BOSTON EDISON

Pilgrim Nuclear Power Station
Rocky Hill Road
Plymouth, Massachusetts 02360

October 4, 1990
BECo Ltr. #90.119

Subject: Boston Edison Company Response to NRC Request for Information on
Offsite Emergency Planning for Pilgrim

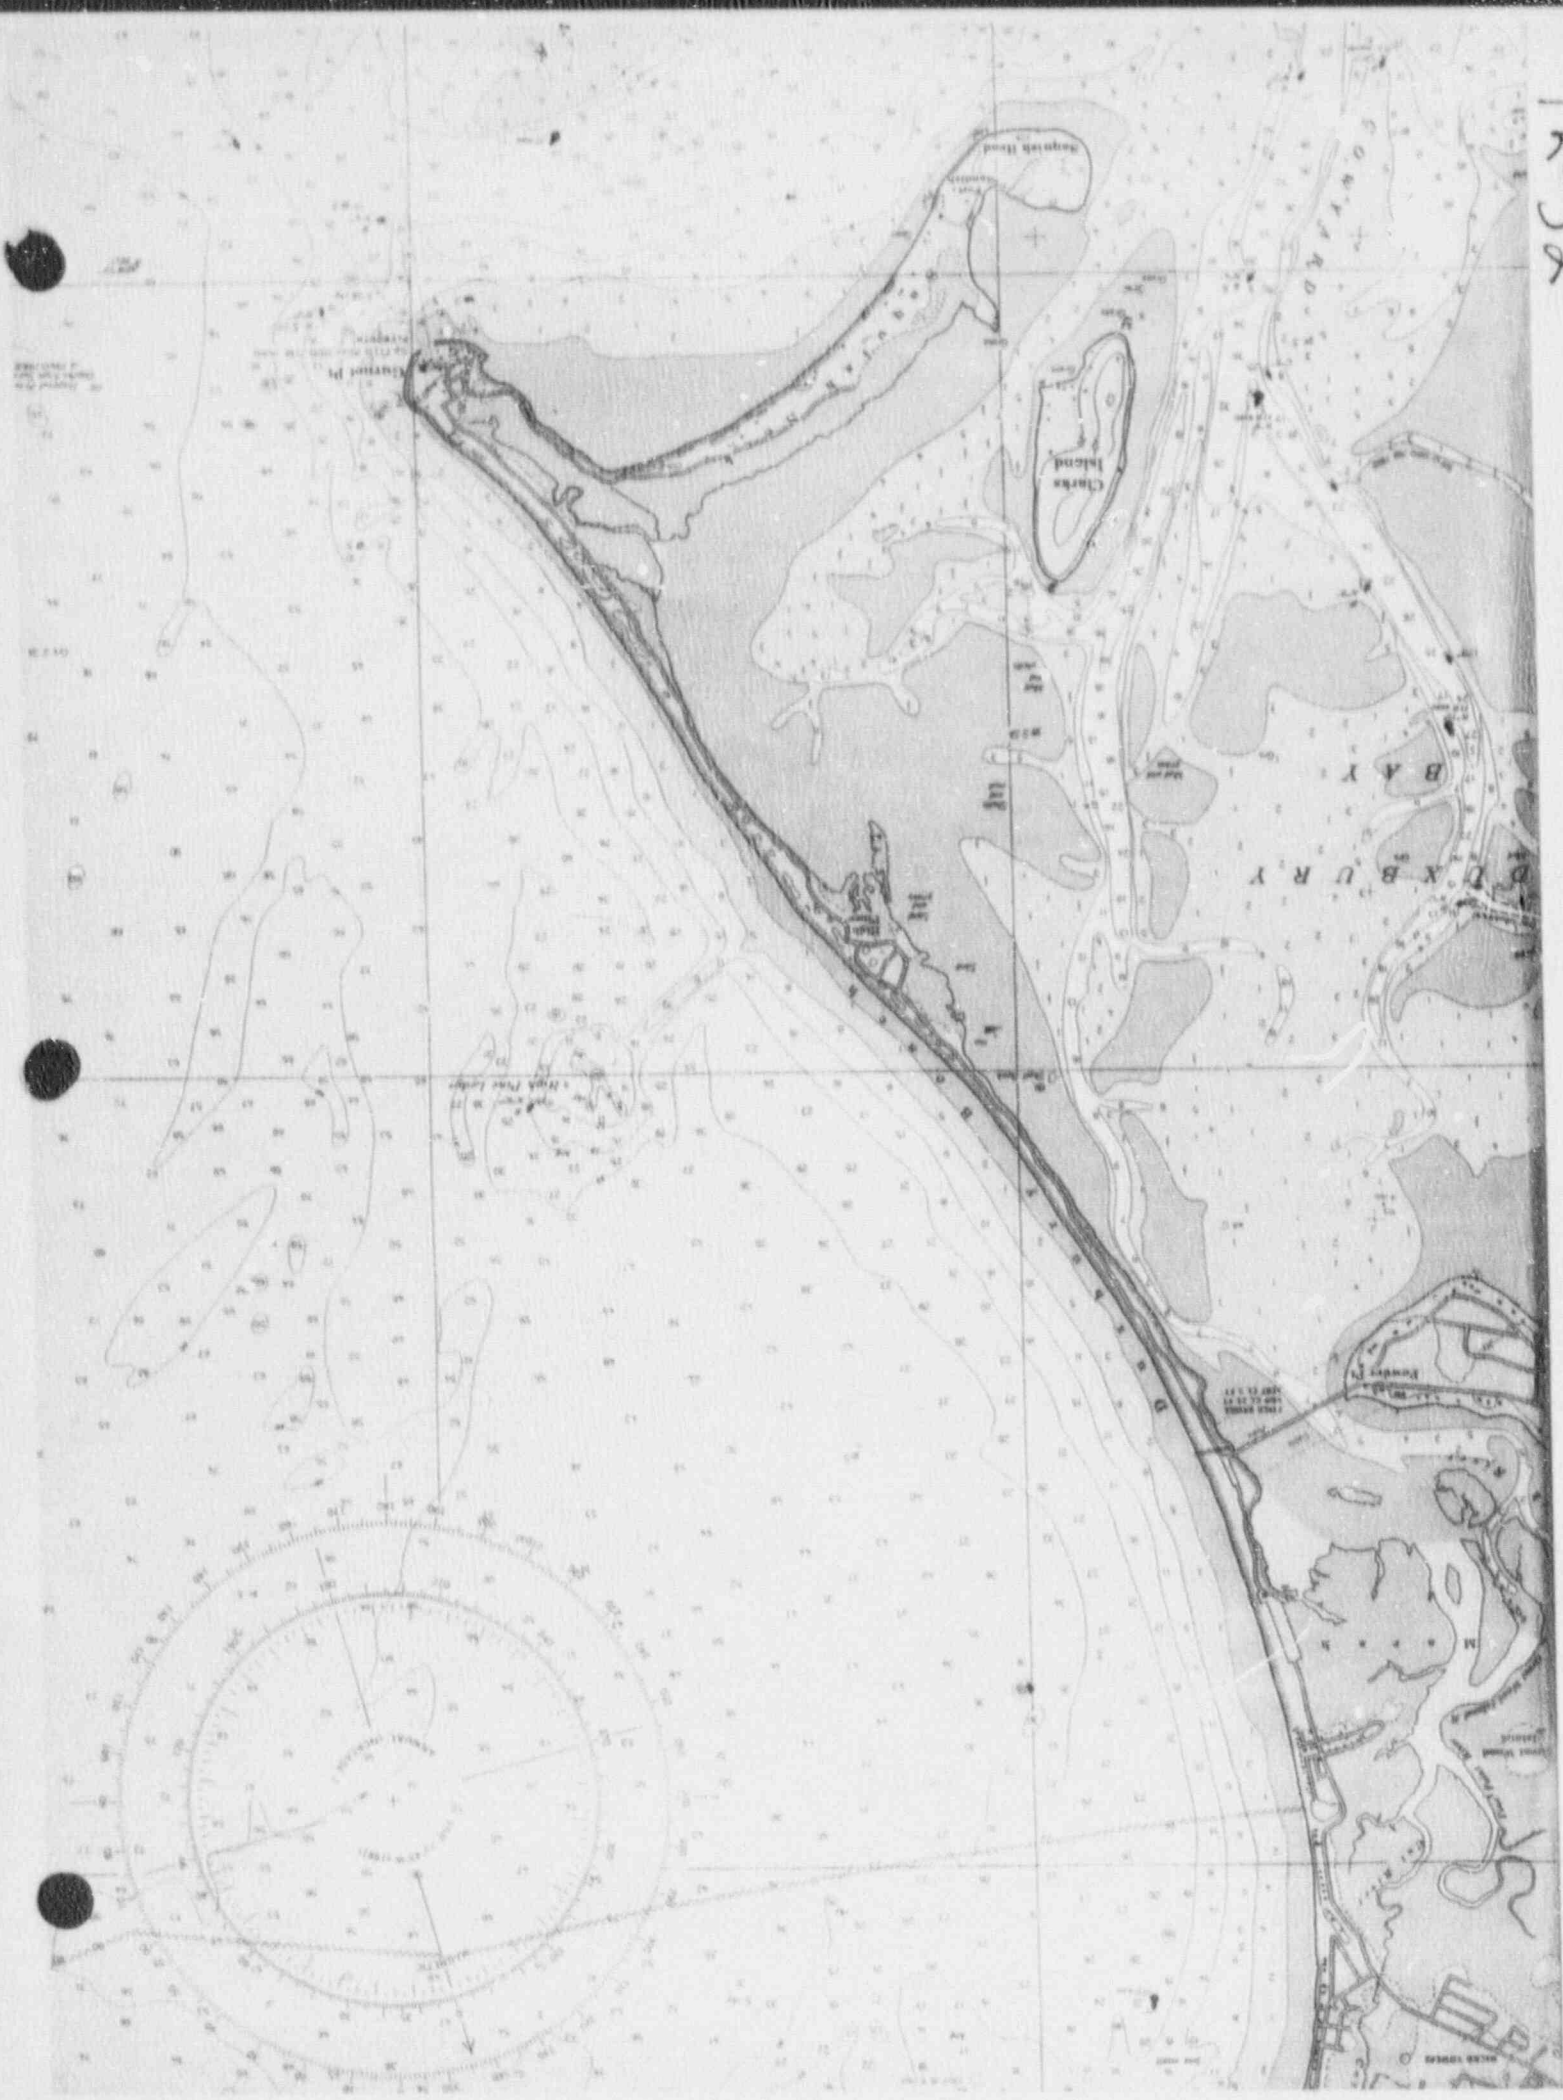
Item No. Tr-32: (cont.)

During low tides, the water at some places around the island can become shallow; however, egress by boat is still possible according to the Duxbury Harbormaster.

CORRECTIVE ACTIONS:

None Required
